## RESPONSE TO REQUEST FOR ADDITIONAL INFORMATION

### APR1400 Design Certification

Docket No. 52-046

RAI No.: 338-8426  
SRP Section: 08.01 – Electric Power – Introduction  
Application Section: 8.1  
Date of RAI Issue: 12/17/2015

Figure 1 Simplified Single Line Diagram of APR1400 Offsite Power Circuits

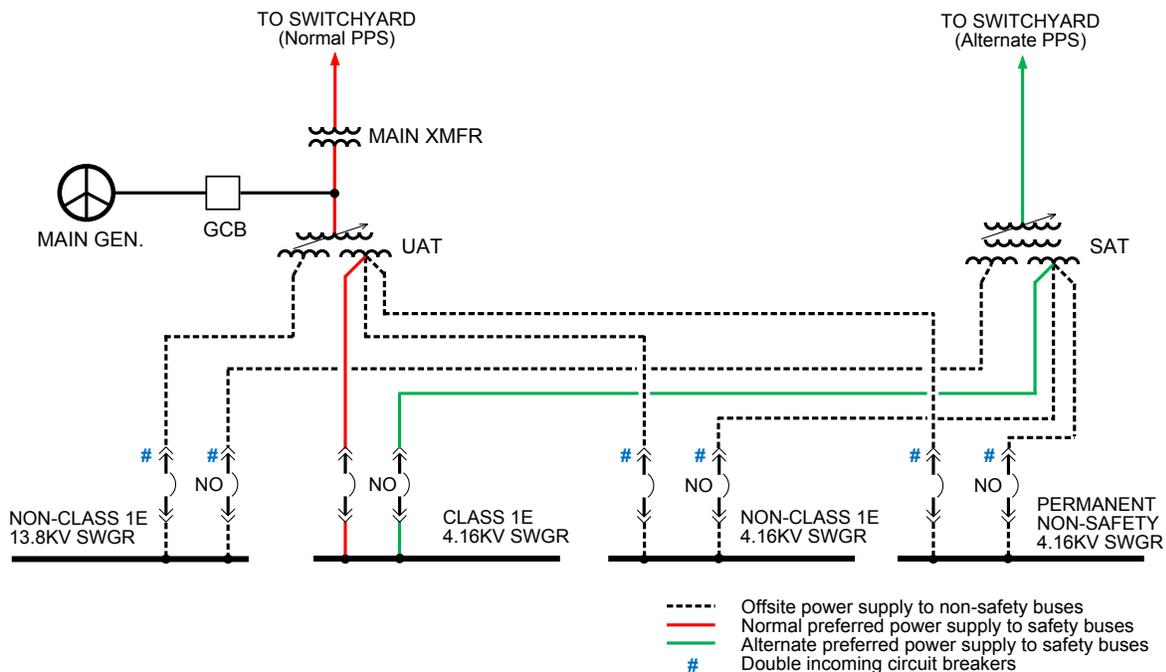
The applicant is requested to provide explanation as to how the proposed design meets GDC 17 requirement, and guidance in SRP 8.3, SECY-91-078, RG 1.32, RG 1.75, and applicable industry standards or provide analysis to demonstrate that the design margins will result in transients from a loss of non-safety power event that is less severe than those associated with the turbine trip only event in current existing plant designs. The applicant is requested to discuss how the electrical system provides a direct connection with no intervening non-safety buses from the offsite power source to the onsite Class 1E system.

A simplified single line diagram is depicted in Figure 1 to illustrate the APR1400 offsite power circuits. For simplicity, the diagram shows only one electrical division and the buses of the same classification and voltage level are indicated as one bus.

In the EPRI ALWR design, the second tier of onsite power distribution system (i.e., PNS buses) establishes intervening connections between the UATs and the safety buses as shown in Figure 2. This is a case of indirect connection through an intervening bus which could cause both the offsite power paths to be unavailable if a non-safety bus (i.e., PNS bus) should fail. For this reason, the EPRI ALWR design makes the provision of a third path, in addition to the existing offsite power supply paths, to provide for a direct connection to the safety buses; thus, making the design satisfy the staff's position in SECY-91-078.

The APR1400 does not need to utilize the third path like the ALWR generic design since the offsite power sources of APR1400 have direct connections to the Class 1E buses. Failure of the non-Class 1E bus will not disable or disconnect the normal or alternate path from the offsite power supply to the Class 1E buses.

In the ALWR design, a direct connection between the offsite power supply and the safety buses is achieved by manually aligning a dedicated path in the event of problems with the non-safety buses (i.e., PNS buses). For the APR1400 design, the direct connection is normally maintained and secured in the event of a problem with any non-Class 1E bus by proper and secure isolation of the failed non-Class 1E bus. In fact, the APR1400 has enhanced the isolation configuration through a redundant breaker scheme to ensure that a

As stated previously, the offsite power source to the APR1400 has direct connections to the safety buses such that the offsite power supply will not be prevented from supplying power to the safety buses upon a failure of any non-safety bus. The direct connection is normally maintained for the APR1400 design as shown in Figure 1 and also adequately secured in the event of a problem with any non-safety bus by proper isolation of the faulted non-safety bus.
